Question 71a: *Core 3-D Flow and Void Distribution (Page 4-85, EMF 2103). Comparison to the THTF and GE Level Swell data, for example, are high pressure tests and do not represent PWR reflood conditions. The GE data does not apply to rod bundle drag. On the other hand, specific FLECHT boil-off or reflood data are applicable to voids in bundles at low pressure (FLECHT-SEASET Test 35658, for example).*

Figure 132.1 Swelling and Rupture Model: PCT Independent of Location

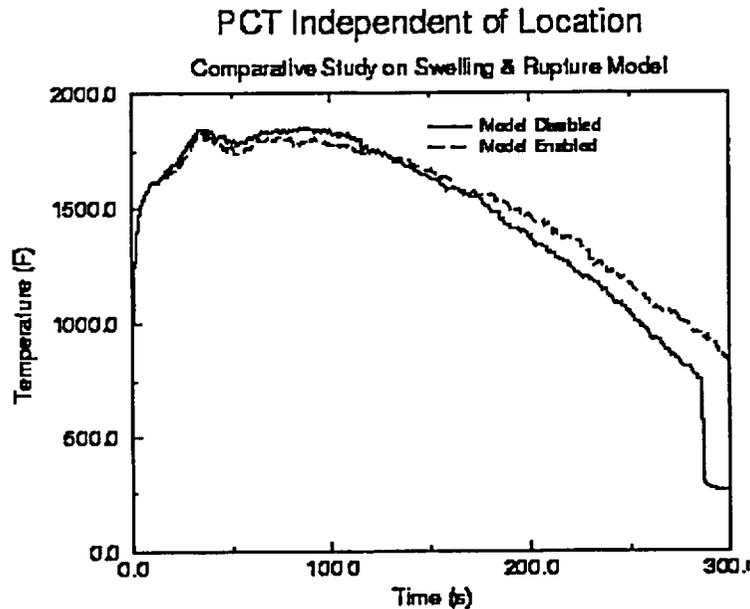
Question 132: *Please show the heat transfer coefficient vs time for Figs. B.3 and B.4. Also show the temperature of the node just above the ruptured region and its corresponding heat transfer coefficient. Also show the gap conductance vs time for the ruptured and unruptured region just above. Are the drop sizes affected by the ruptured region. What is the void fraction and corresponding drop sizes versus time at the hot spot?*

figures provide the requested results from the additional sensitivity study. The first figure presents a PCT comparison for a calculation including the swelling and rupture model vs. the base case. As with the calculations given in Section B.2, PCT is reduced relative to the base case. In addition, examination of the oxidation criteria shows that the base case results also bound the swelling and rupture case. The second figure shows the heat transfer coefficient vs. time for the two cases at node 28 which is the rupture node when the swelling and rupture model is enabled (indicated as "Modeled Enabled" on the figures). Also, from the "Model Enabled" calculation, the heat transfer coefficient is shown for the node immediately above the rupture node. The third figure shows the clad temperature traces at these same three nodes. The last figure shows the gap conductance. The drop in gap conductance which begins around 13 s is from the rod swell. Around 18 s the rod ruptures and the gap conductance drops to its eventual minimum value.

The swelling and rupture model does not take credit for the likely liquid deentrainment that would occur as a result of this condition. In addition, the Forslund-Rohsenow dispersed flow film boiling correlation is unmodified for this condition. The deentrainment phenomenon is expected to be a PCT benefit and by not considering its effects in S-RELAP5, the analyses possess this conservatism. A discussion of void fraction and droplet size at the hot spot is presented in the response to Question 123.

Figure B.3 Comparison of Original Thermocouple Signal and the Filtered Signal for Thermocouple TE-320AG of Test 3.02.10C

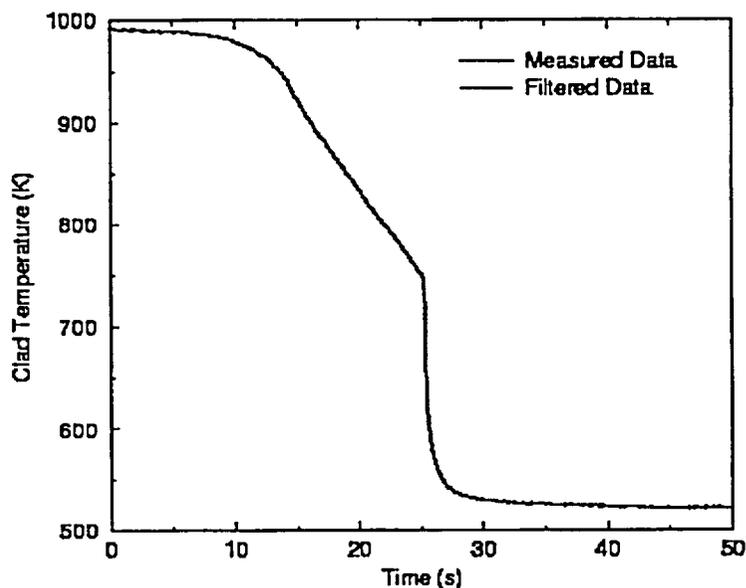
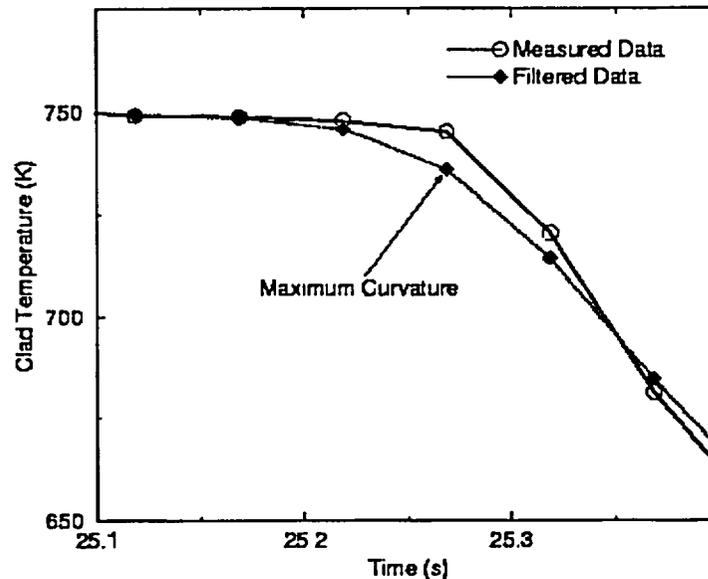
- The thermocouple signal is noisy and to prevent false indications of quenching, the signal has been filtered before it was analyzed. How much does this filtering distort the value of the quench temperature?
- The quench temperature is based on the filtered thermocouple signal and the thermocouple is located on the interior of the clad surface. How much does the actual clad surface temperature differ from the thermocouple reading?

The following two figures illustrate the temperature differences that can result from filtering the thermocouple signal. In the first, Figure B.3, there is no discernable difference between the original and the filtered signal. At an extremely fine scale focused on the quench point (Figure B.4), it is observed that the filtered signal has a smoother shape and under-predicts the temperature at the point of maximum negative curvature. For this particular example, the temperature difference is ~ 9 K. Of course, the exact value of this under-prediction varies from thermocouple to thermocouple and from test to test, however, this example gives a good indication of the trend towards under-prediction and its approximate magnitude.
